Access Compliance Report

Public Rights-of-Way

(Curb Ramps)

Intersection ID: 14859	Main Street: BRIAR_CREEK_RD	Cross Street: COLONNADE_DR	Location: NW
ADA ID: D9A6C70F8360	Ramp Type: PerpDiag	Initial Pass/Fail: Fail	Overall Compliance: No
			Severity Score: 21.25

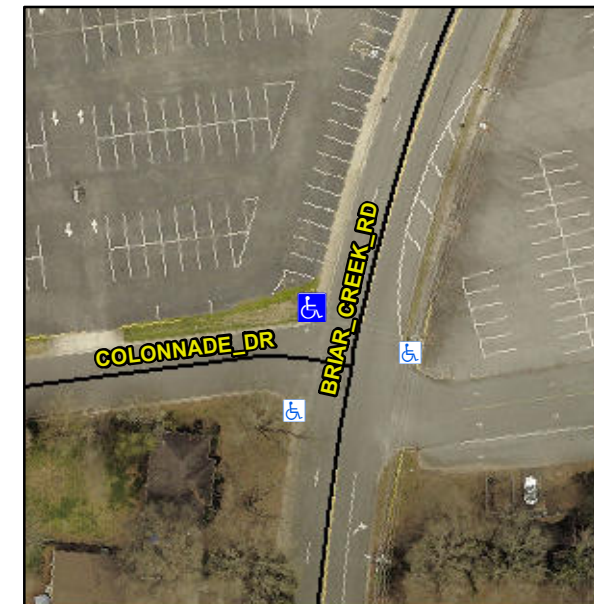
Not Found, R304.5.1, R304.5.3

Compliance	Description	Data	Compliance	Description	Data
N/A	Ramp Length (in)	24.0	Yes	Ramp Slope (%)	8.1
No	Ramp Width (in)	40.0	No	Ramp XSlope (%)	5.7
N/A	Flare Type LT	N/A	N/A	Flare Type RT	N/A
N/A	Flare Slope LT (%)	N/A	N/A	Flare Slope RT (%)	N/A
N/A	Flare Traversable LT?	N/A	N/A	Flare Traversable RT?	N/A
N/A	Landing Length (in)	N/A	N/A	DWS Provided?	N/A
N/A	Landing Width (in)	N/A	N/A	DWS Contrast?	N/A
N/A	Landing Slope (%)	N/A	N/A	DWS Length (in)	N/A
N/A	Landing X Slope (%)	N/A	N/A	DWS Full Width?	N/A
N/A	Landing Curb? (Y/N)	N/A	N/A	DWS Offset (in)	N/A
N/A	Shared Landing?	N/A			
N/A	Gutter Ponding?	N/A	N/A	Gutter Slope (%)	N/A
N/A	Gutter Lip Ht (in)	N/A	N/A	Gutter X Slope (%)	N/A
N/A	Painted X Walk1?	No	N/A	Painted X Walk2?	No
	X Walk 1 Direction	To SW		X Walk 2 Direction	To SE
N/A	X Walk 1 Width (in)	N/A	N/A	X Walk 2 Width (in)	N/A
	X Walk 1 Slope (%)	7.3		X Walk 2 Slope (%)	5.6
	X Walk 1 X Slope (%)	0.2		X Walk 2 X Slope (%)	5.5

Remove & Replace Curb Ramp With Two New Directional Ramps or Equivalent.
